**BC05-186**  
**Annex Page 1**

**PHRSG-YYY Desuperheater Drain Pots**

FOR INFORMATION ONLY  
ITEM BC05-186 AS PASSED

**Figure PHRSG-4**  
**Some Acceptable Desuperheater Spraywater Protection Device Arrangements**

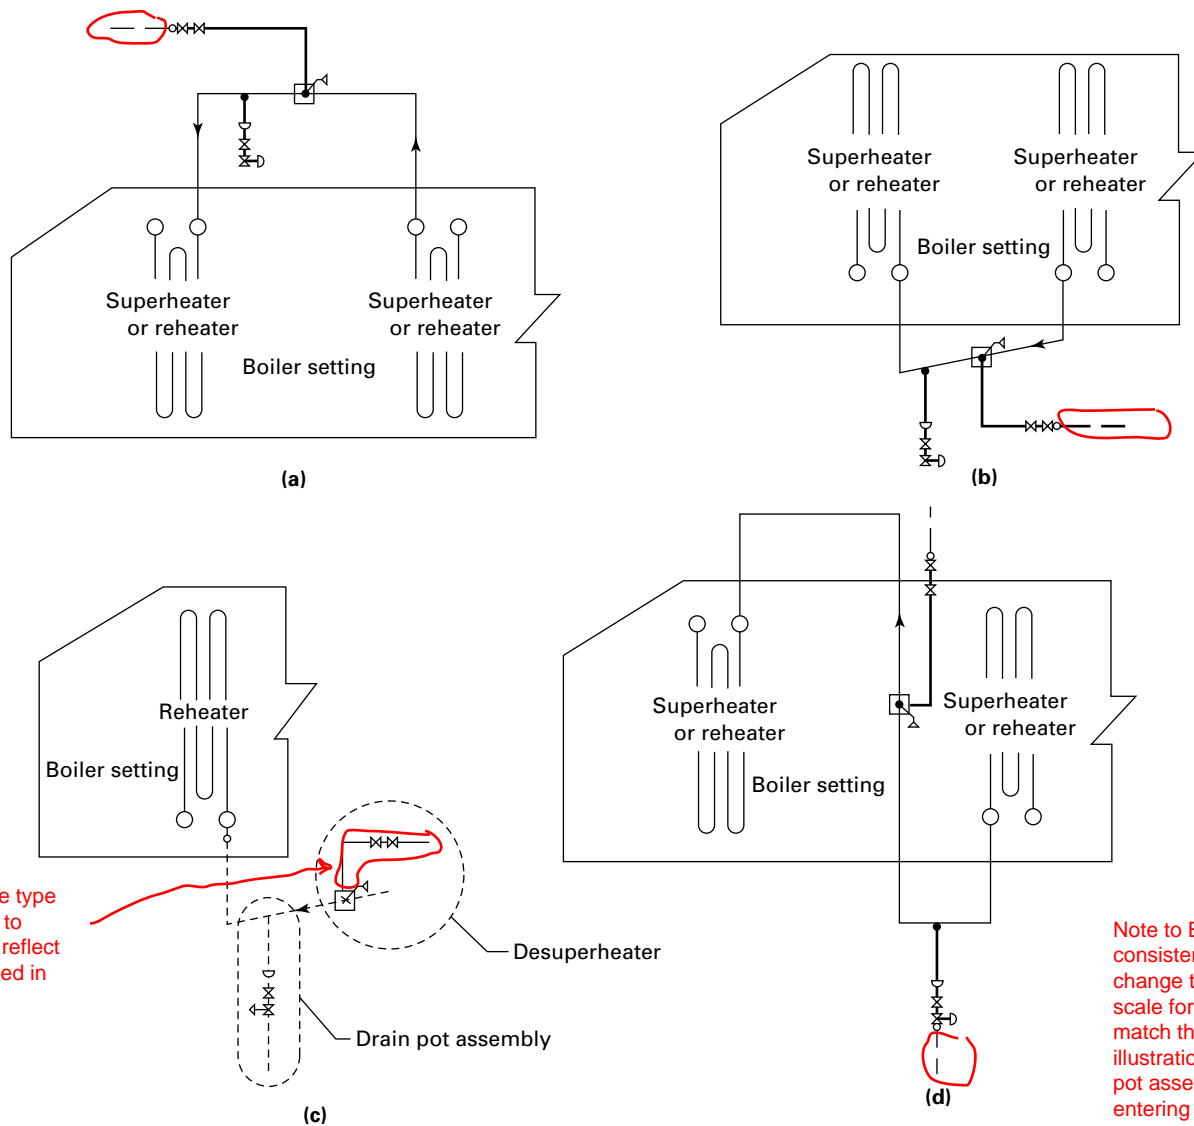
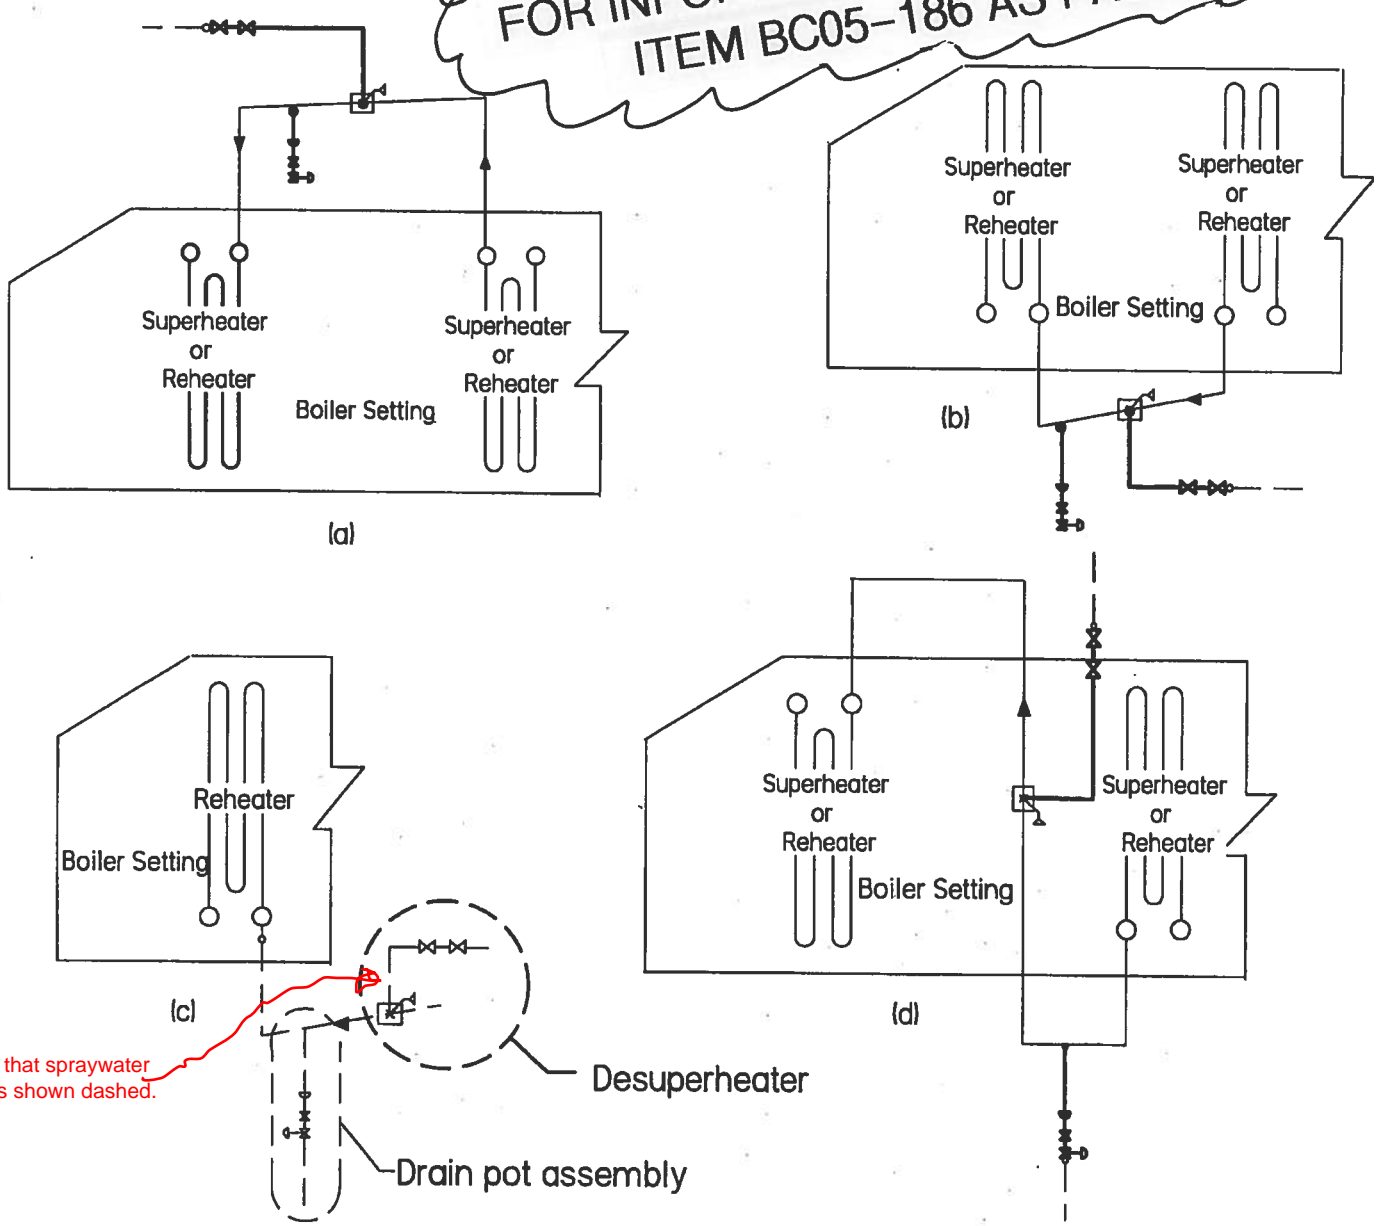
Where desuperheater spray water is injected into superheater or reheater piping as a means to control steam temperature the following shall be provided:

- (a) Drain pots to detect and remove unvaporized spray water shall be installed in the boiler proper or boiler external piping either upstream or downstream of the desuperheater to ensure malfunctions of these devices will not allow water to enter hot boiler components. Drain pots shall include automatic detection of water and automatic operation of the drain pot valves as shown in Fig. PHRSG-YYY. Piping from the drain pot shall conform to the requirements of PHRSG-XXX (Requirements for Superheater and Reheater Condensate Removal Connections).

- (b) Drain pot connection size shall be no smaller than one NPS less than the pipe it is attached to, except it need not be greater than NPS 12 (DN 300).

- (c) Drain pots, with single element level control with time delay to close, are an acceptable method of detecting and removing unvaporized spray water.

- (d) Piping layouts shall be sloped in all operating conditions so that unvaporized spray water from the desuperheater can not bypass the drain pot.
- (e) All desuperheater drain piping shall be routed to a blowdown or flash tank, manifold or other collection device. The collection device shall not operate at a higher pressure than the space being drained.
